ISSUE DATE: 1/5/07

ON-SITE SEWAGE DISPOSAL SYSTEM HOWARD COUNTY HEALTH DEPARTMENT BUREAU OF ENVIRONMENTAL HEALTH

Fogles Septic IS PERMITTED TO INSTALL ☒ ALTER ☐
ADDRESS: 580 Obrecht Rd PHONE NUMBER: 410-795-5670
SUBDIVISION: Homewood Crossing LOT NUMBER: 32
4921 ~~4931~~
ADDRESS: ~~4921~~ Valley View Overlook PROPERTY OWNER: Toll MD III LP
SEPTIC TANK CAPACITY (GALLONS): 1250 OUTLET BAFFLE FILTER REQUIRED ☐
PUMP CHAMBER CAPACITY (GALLONS): _____ COMPARTMENTED TANK REQUIRED ☒
NUMBER OF BEDROOMS: 4
SQUARE FEET PER BEDROOM: 210
LINEAR FEET OF TRENCH REQUIRED: 199

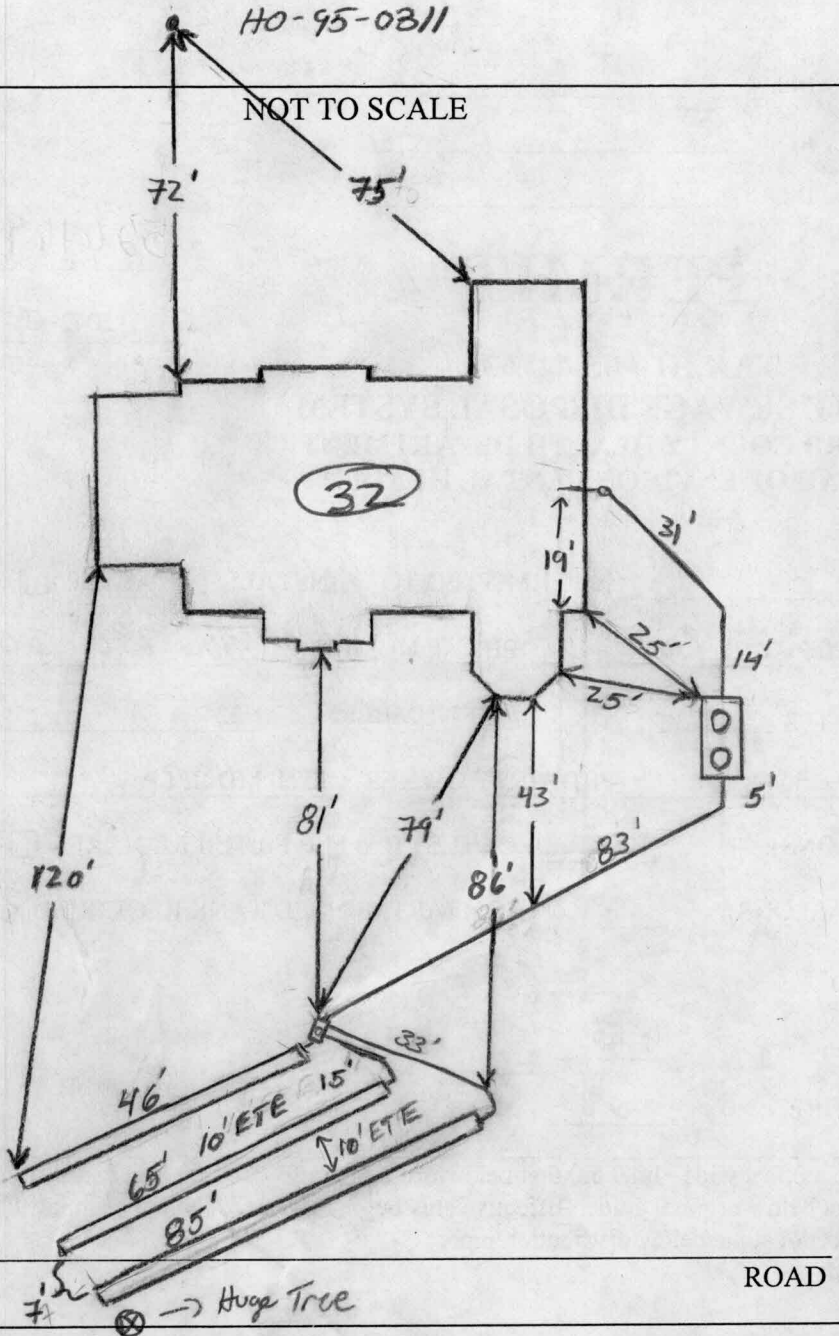
PRE-CONSTRUCTION 1/9/07 As I arrived on site, contractor had already laid out system and dug all trenches and stoned

INSTALLATION all trenches. D box set. S.T. set. No baffles in tank. Plumbing from house to tank - D box not installed. D box needs levelers. 1/10/07 D box levelers. All plumbing installed. Baffles in tank. OK. to backfill (Kiu)
